**RE: Technical Comments on Permit Modification 26-1 (Updated Closeout Plan) Application,
Permit No. OT006MN (Mod 26-1), Iron Duke Mine in Otero County, NM**

Attachment A: MMD Technical Comments

Iron Duke Mine
Permit No. OT006MN
Date: April 28, 2026

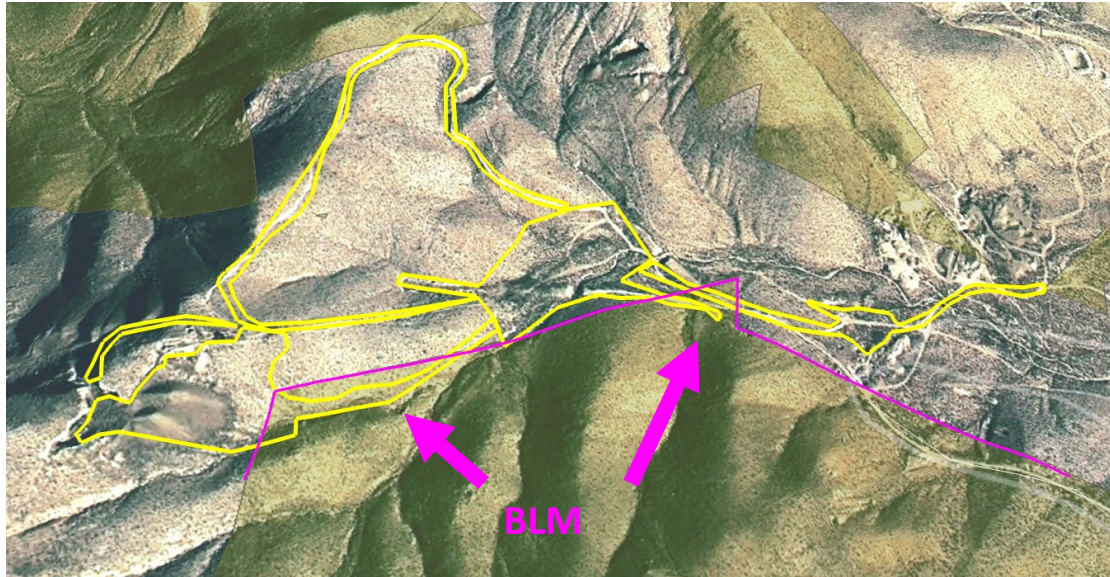
20. Page 6: The former rail grade should include the area number for clarity.

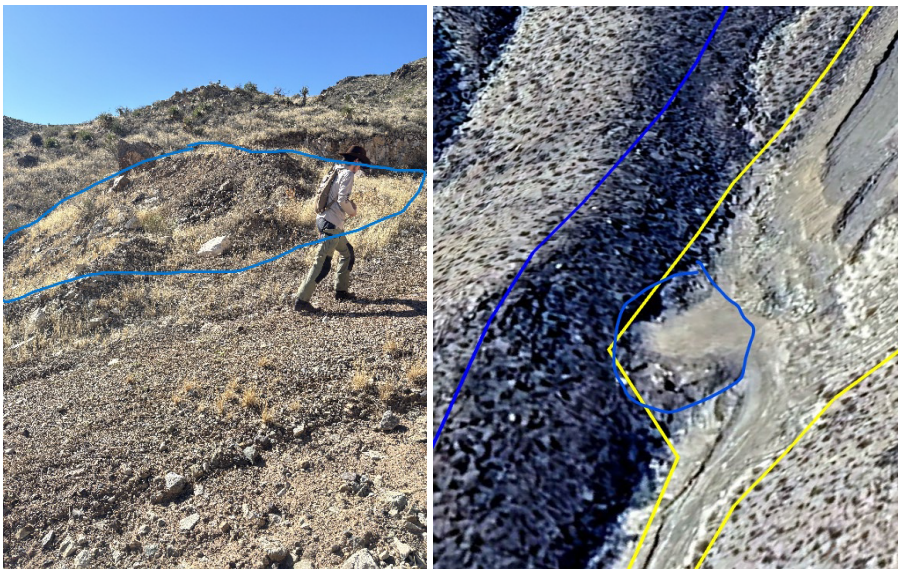
31. Schedule of Closeout Activities: Waste rock removal is “operational” in nature, this does not affect the closeout activities.
32. Part of Closeout Activities needs to include details on re-establishing drainage. Pad 15, will not only need to be re-graded but the backfilled natural drainage that created the “pad” needs to be excavated, reinforced and re-established.

The current proposal has a pond feature in this location, based on MMD’s site inspections, leaving this backfill as a pond feature would not be a long-term solution, the natural drainage should be re-established to keep water from flowing into the road cut. Blue material in image below creates a dam feature and needs to be excavated.
